GENERAL APPLICATION

Location Address: 2022 & 206 Fletcher Street

**RE: 2022-2026 Fletcher Street
Response to Landscape Comments Received**

SUBJECT: Preliminary Site Plan review for a 42- Unit residential development.

C-1.4
 OF SHEETS

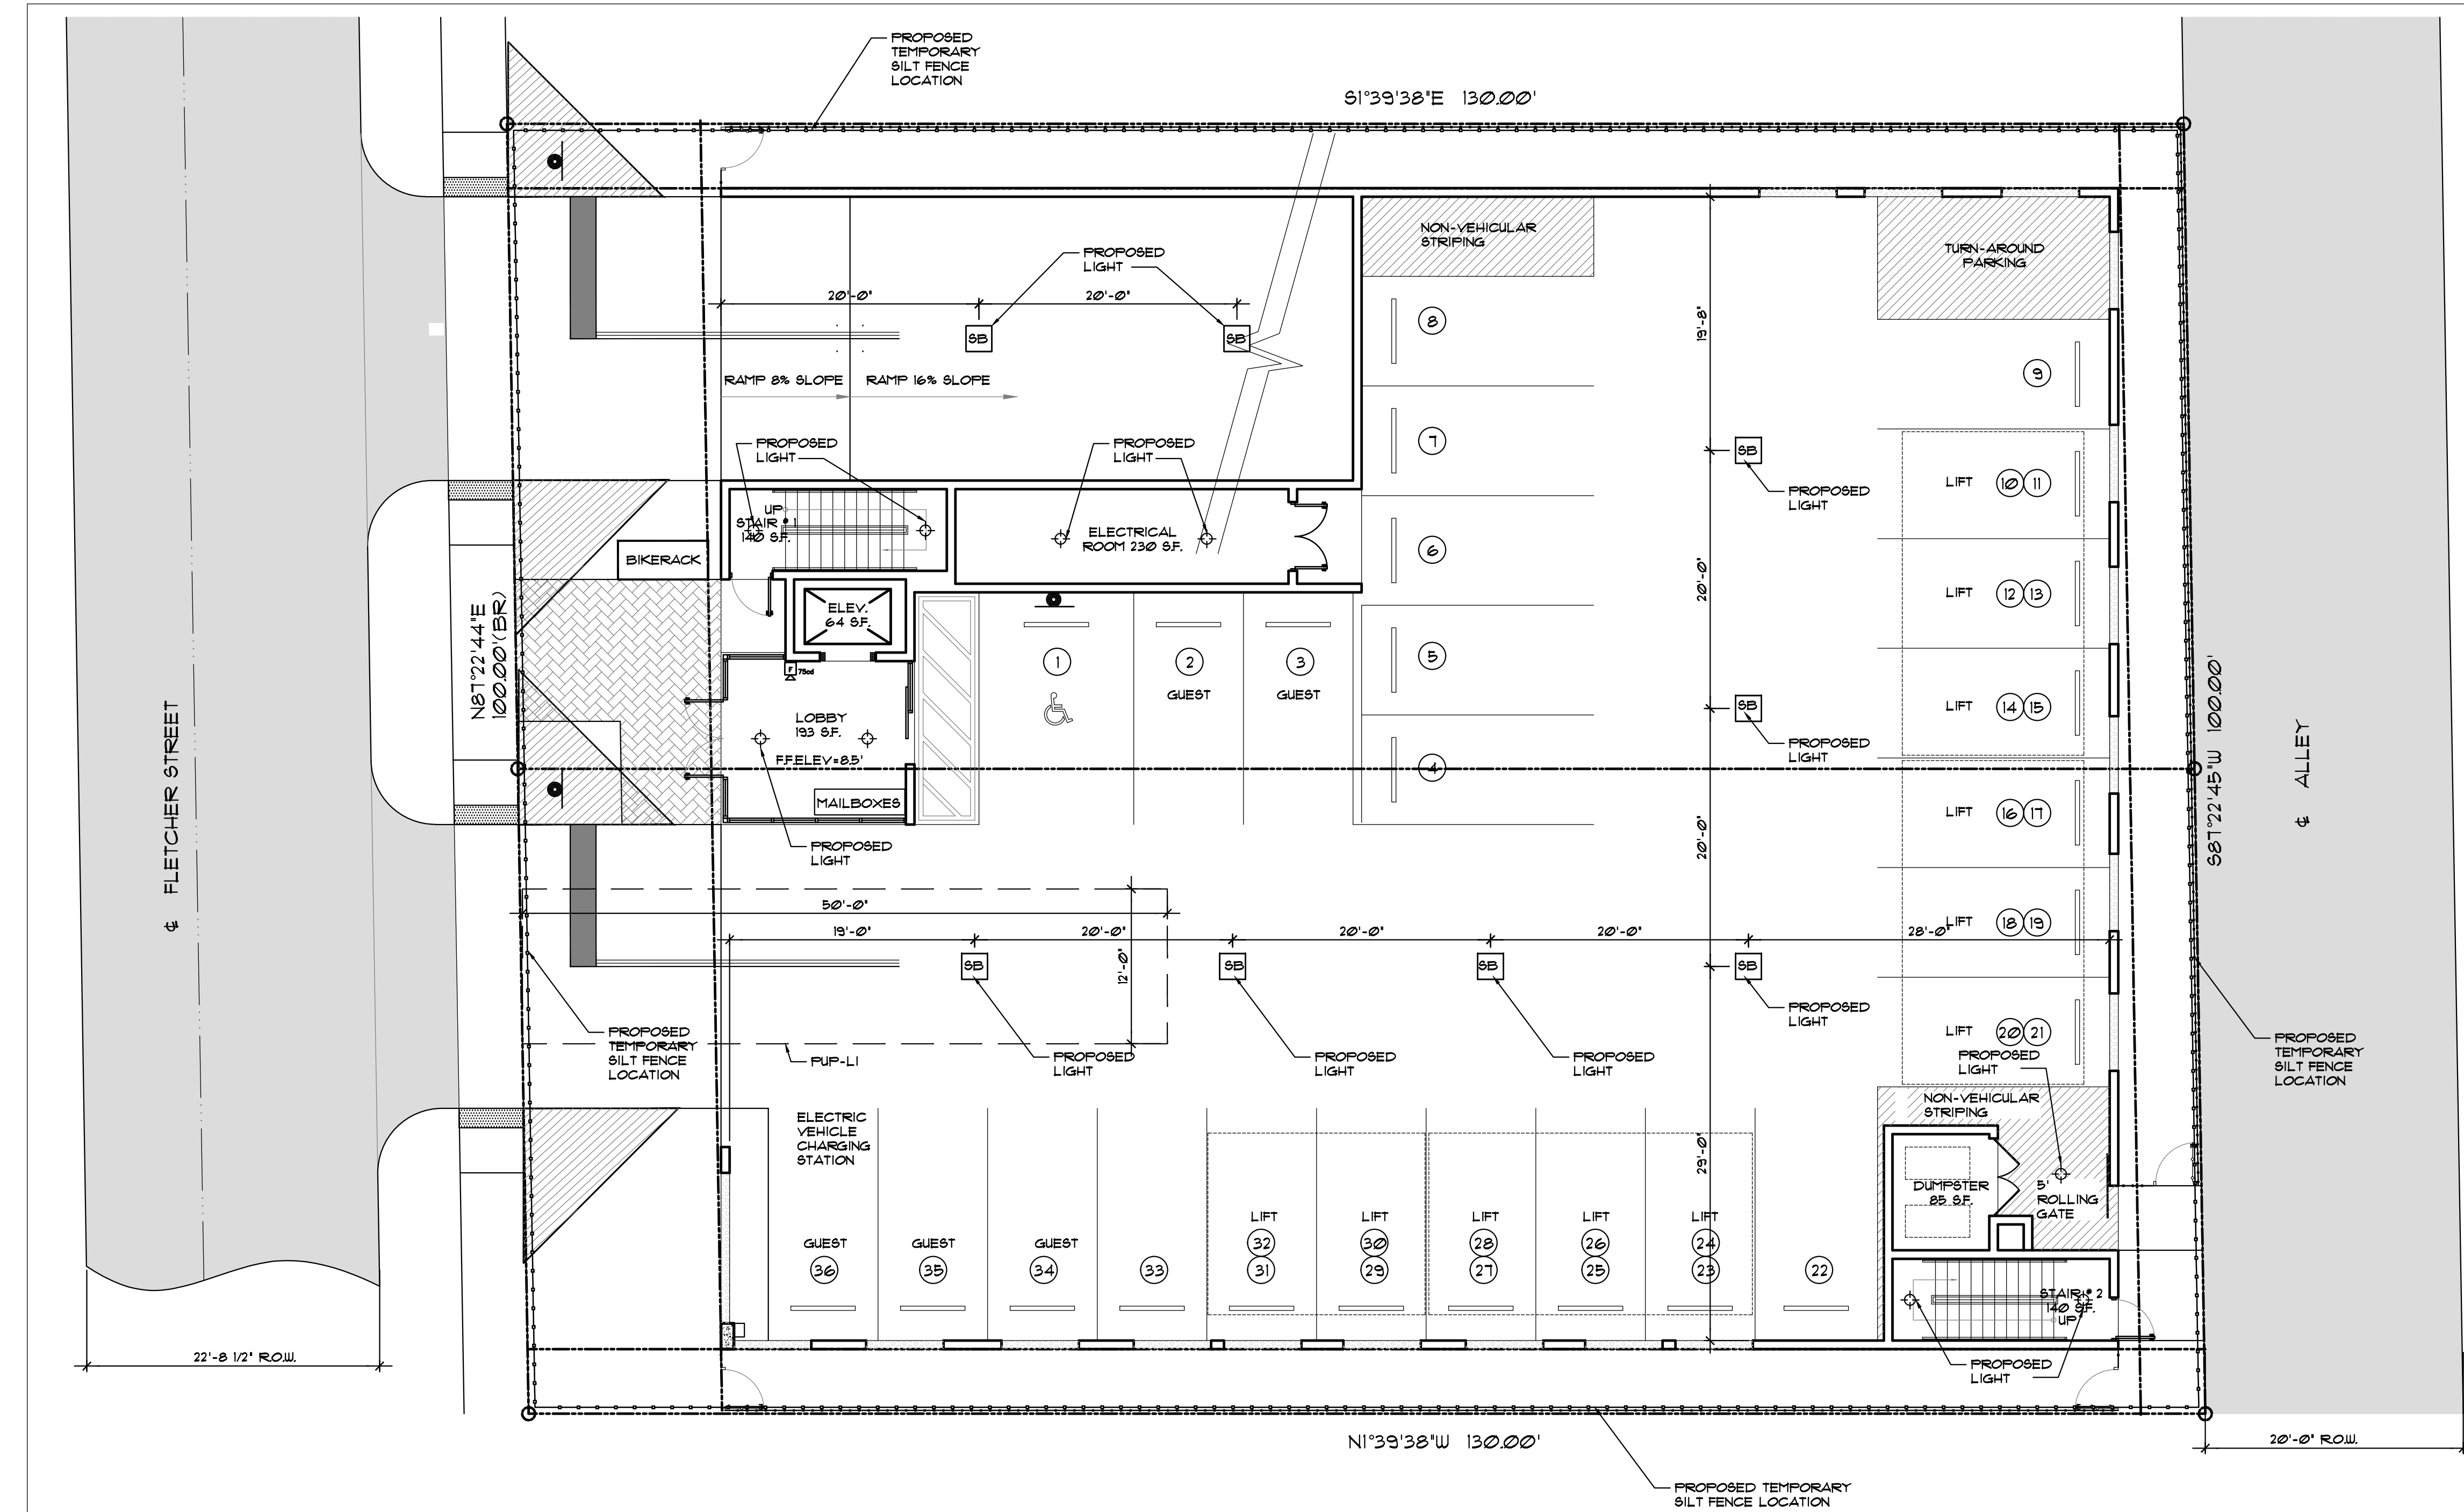
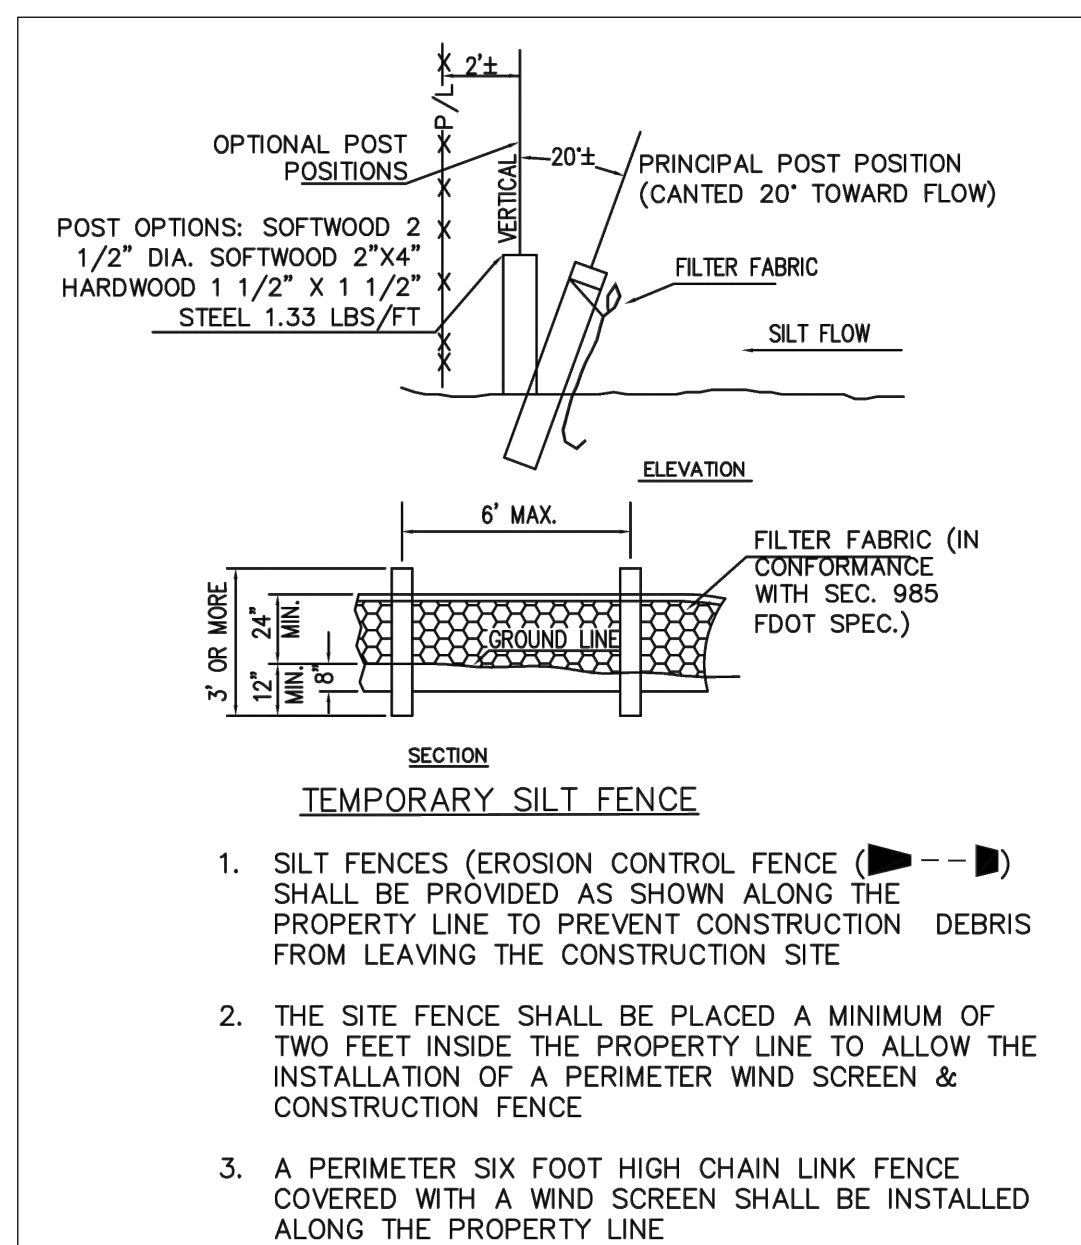
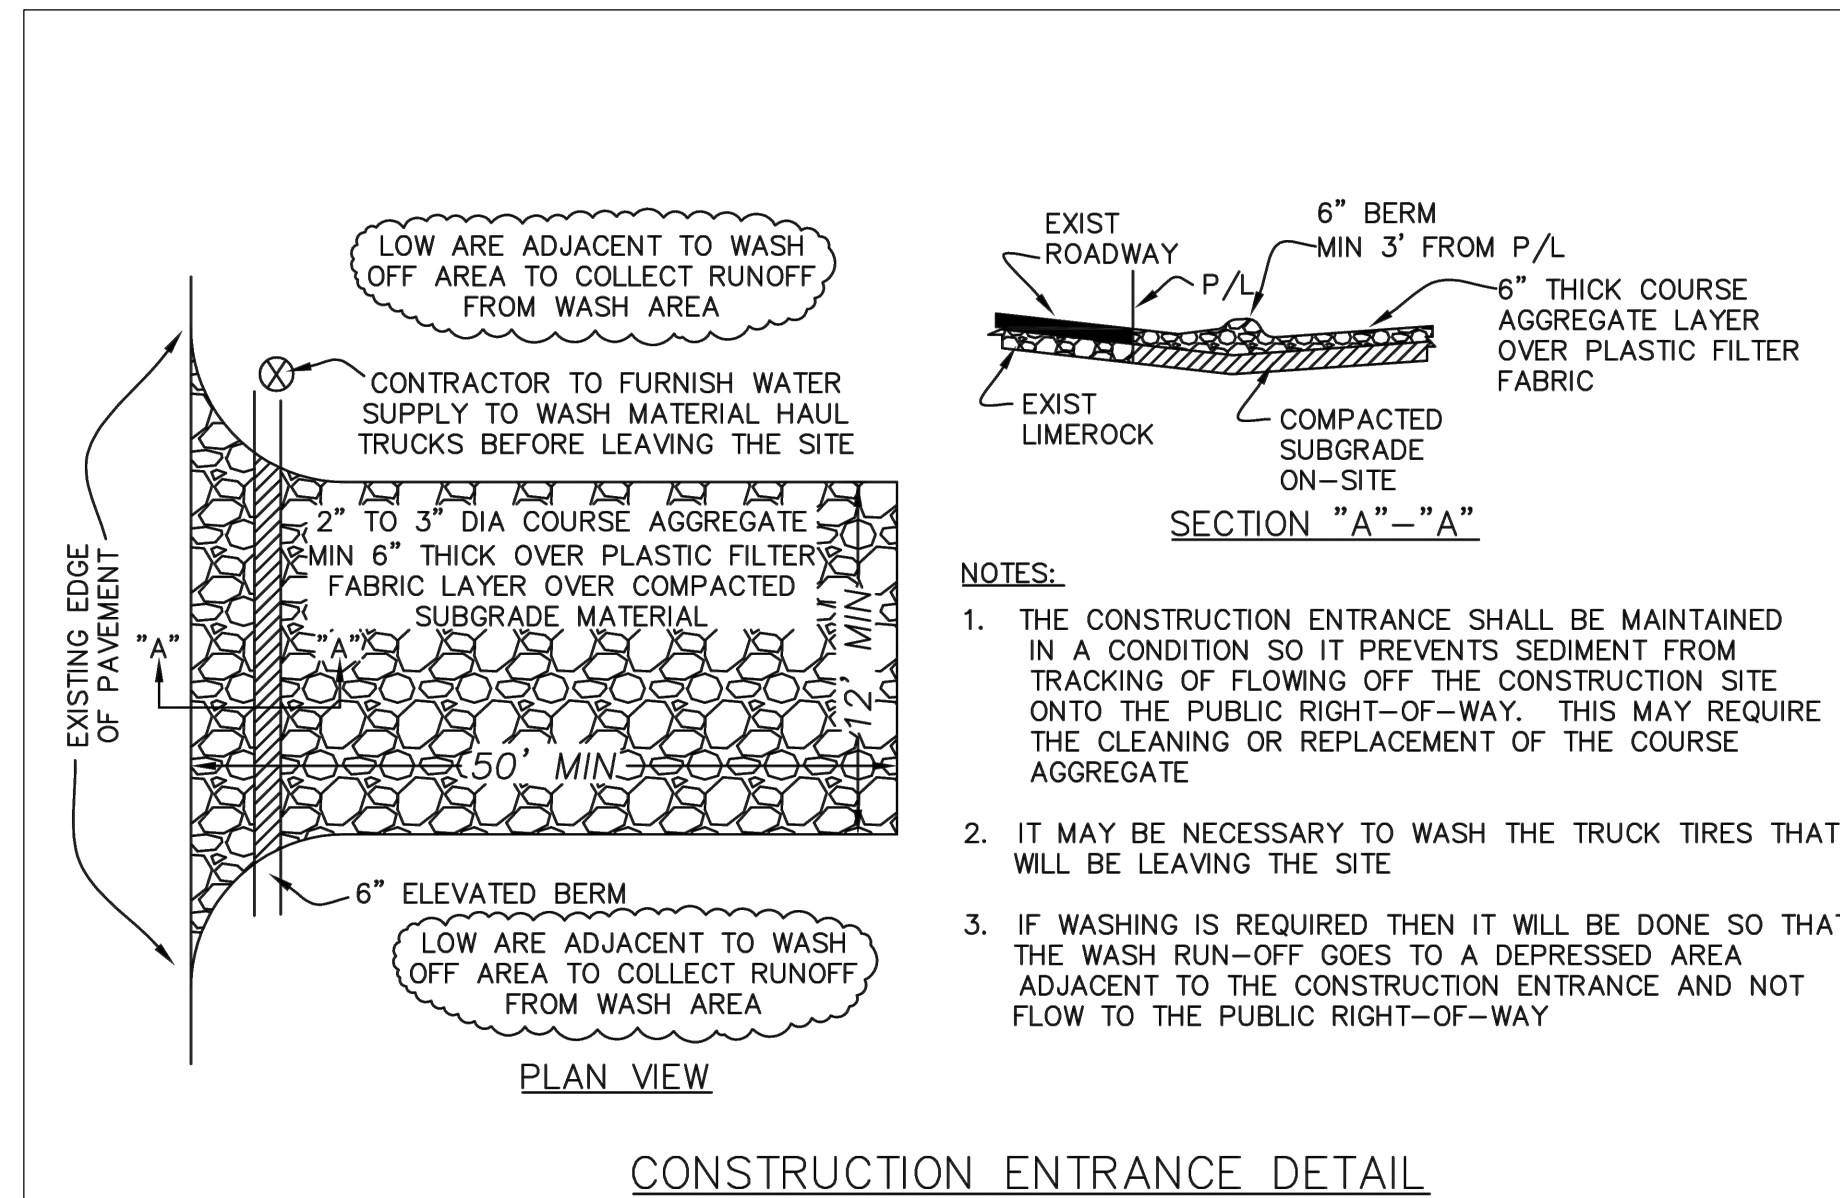
17. Provide pavement marking and signage plans.

Response: Refer to C-1.4
